SERVICE BULLETIN

No. 649

AXLE NUT LOCK KIT / Z-90

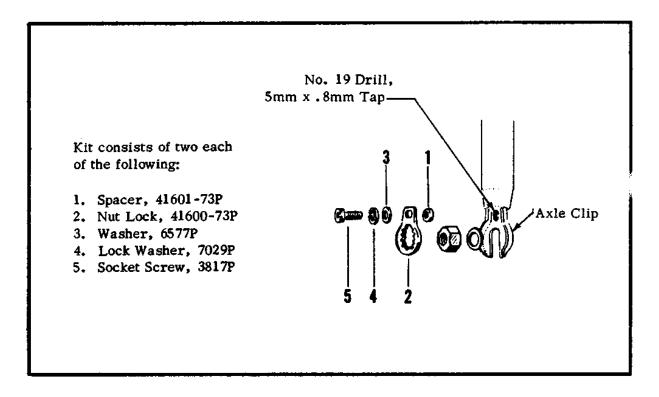
Starting with Model Z-90 VIN 3D 13857H3, an improved method is used to retain the front axle in the front fork axle clips. A nut lock fits over the hex of each axle nut and is held in place with a socket screw, fitting a tapped hole in the axle clip.

The locking clip parts, items 1, 2, 3, 4 and 5 as shown in the following illustration, are available in kit form under part No. 41602-73 for application to early 1973 motorcycles. Each kit contains parts for one motorcycle.

Installation will require drilling and tapping both slider axle clips using a No. 19 drill and 5 mm. x .8 mm . tap.
